<b>Title - Sujet</b> LEONARD J COWLEY VLE REFIT- 2015	
<b>Solicitation No. - N° de l'invitation</b> F7049-140286/A	<b>Amendment No. - N° modif.</b> 011
<b>Client Reference No. - N° de référence du client</b> F7049-140286	<b>Date</b> 2015-01-30
<b>GETS Reference No. - N° de référence de SEAG</b> PW-\$\$MD-021-24828	
<b>File No. - N° de dossier</b> 021md.F7049-140286	<b>CCC No./N° CCC - FMS No./N° VME</b>
<b>Solicitation Closes - L'invitation prend fin</b> <b>at - à 02:00 PM</b> <b>on - le 2015-02-09</b>	<b>Time Zone</b> <b>Fuseau horaire</b> Eastern Standard Time EST
<b>F.O.B. - F.A.B.</b> <b>Plant-Usine:</b> <input type="checkbox"/> <b>Destination:</b> <input type="checkbox"/> <b>Other-Autre:</b> <input type="checkbox"/>	
<b>Address Enquiries to: - Adresser toutes questions à:</b> Byron, Dan	<b>Buyer Id - Id de l'acheteur</b> 021md
<b>Telephone No. - N° de téléphone</b> (819) 956-0691 ( )	<b>FAX No. - N° de FAX</b> (819) 956-7725

**Solicitation Amendment # 11 is issued to:**

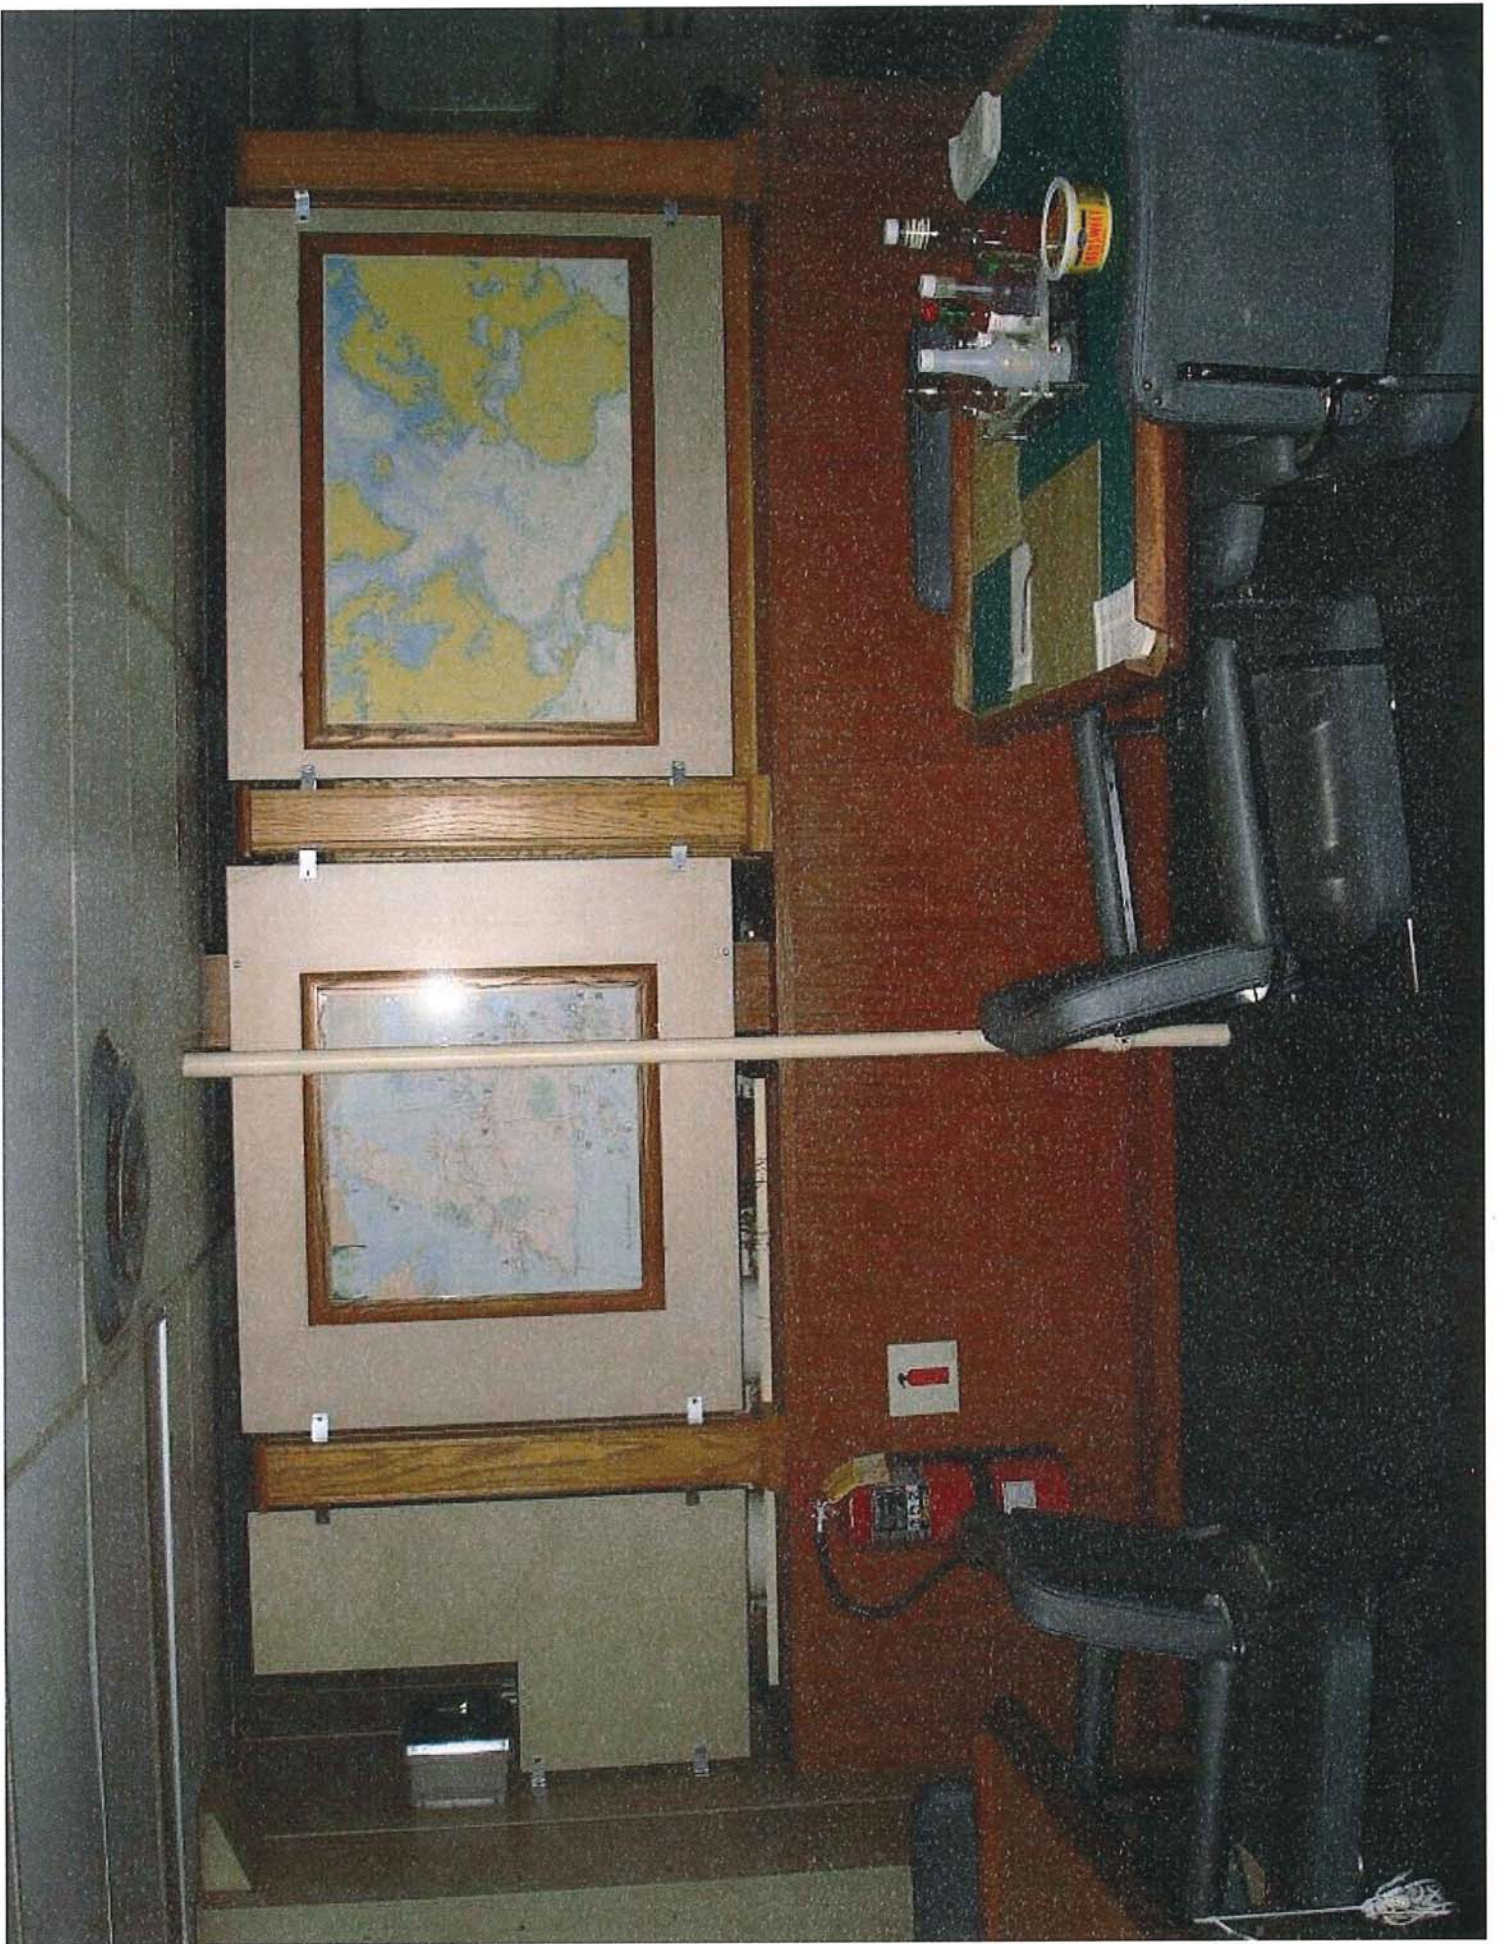
77	In light of the volume of material contained in the specification, and the questions that have yet to be addressed by the Crown, it would be very beneficial to have additional time to prepare our bid.	Bid closing extended to Feb 9 2015
78	H-15: Would it be possible to have a picture sent of these 2 items (as per question 74)?	photos of areas will be provided.

75	L-02 : Is it possible to have the installation drawing and the cable plan in order to be able to evaluate the number and cable and the size required?	As detailed above highlighted in yellow, the cabling requirements are listed. Details on actual cable diameters would have to be from Woodward FSR as listed in spec. Cables are included as part of the upgrade kit, so cable is install only with FSR doing all terminations in panels.
76	H-15 – 3.5.5.2 – please provide drawings as indicated for the Crew's lounge and officer's lounge entertainment units	no drawings available.
